Product Change Notification

112027 - 00

Change Notification #: 112027 - 00
Change Title: Intel® Server Chassis P4208XXMHGC, P4308XXMFEN, P4308XXMHEN, and Power Supply FUP365SNRPS
PCN 112027-00, Product Design, Label Update Front Panel, Packing Regulatory Label, Cables and Connector
Date of Publication: January 21, 2013

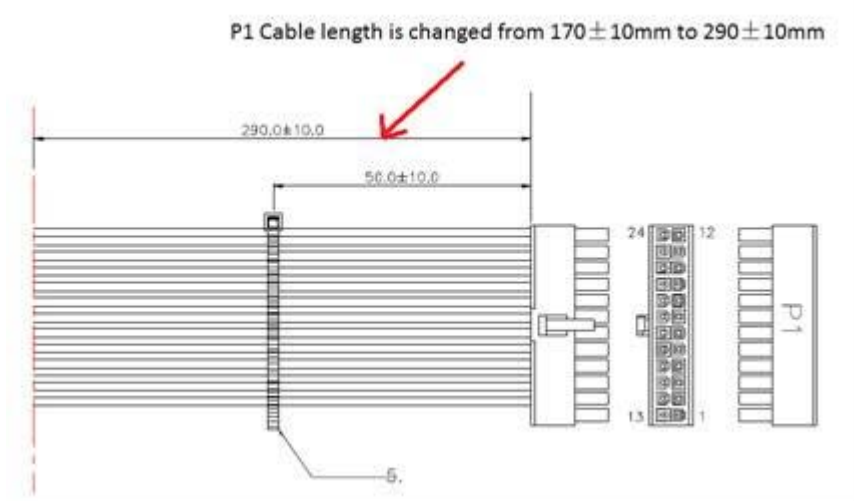
- The Printed circuit board (PCB) of front panel will have four resistors added to improve the LED brightness.
- Package regulatory label to be updated with Perchlorate Statement. See below picture.

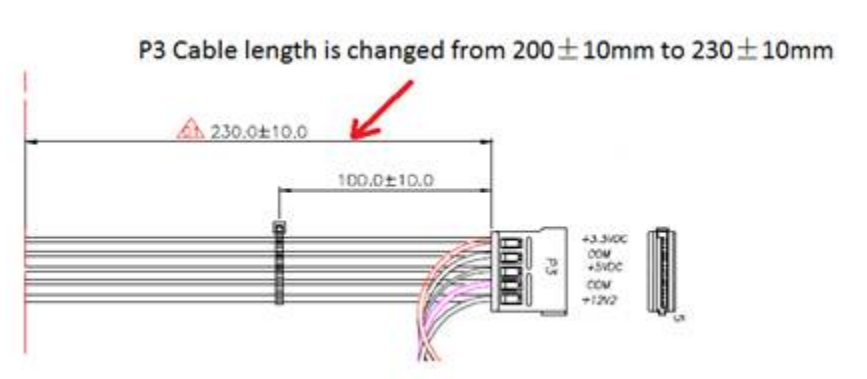
- Cable length of P1 connector to be changed from 170mm to 290mm.

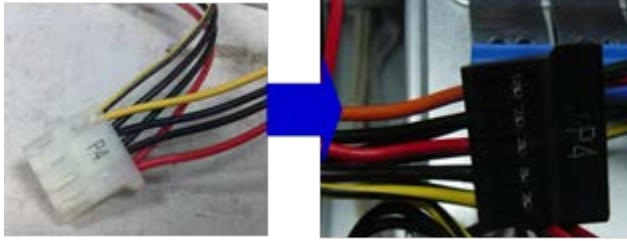
- Cable length of P3 connector to be changed from 200mm to 230mm.
